Subject: Request for additional information (FCC ID: IHDT6DV1)

Applicant Received:	12/03/2003
Correspondence Reference Number:	240206A.IHD
Confirmation Number:	TC3306
Date of Original Email:	12/08/2003

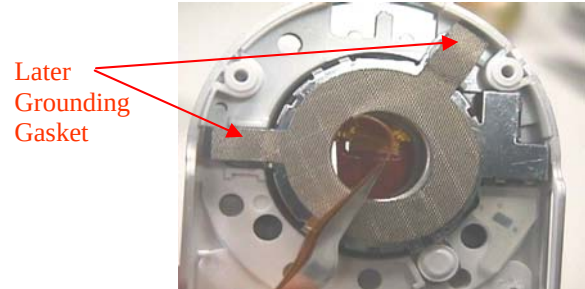
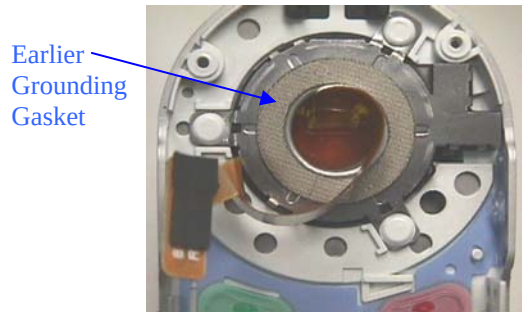
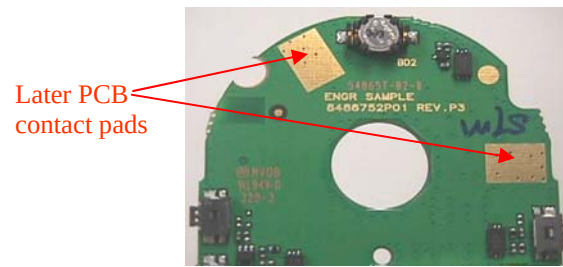
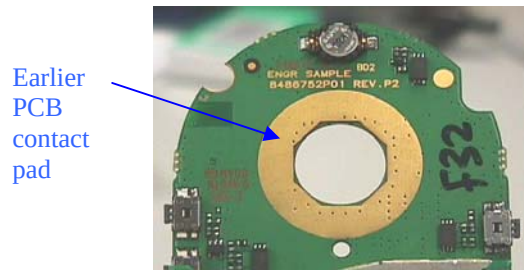
2. Why was the addendum to the original SAR report submitted? What changed, requiring the new body-worn SAR tests?

Response: The grounding method for the rotating housing was changed, as illustrated in the following. (Note: This change required complete testing of both EMC and SAR. Degradation is reported only for the body worn SAR.)
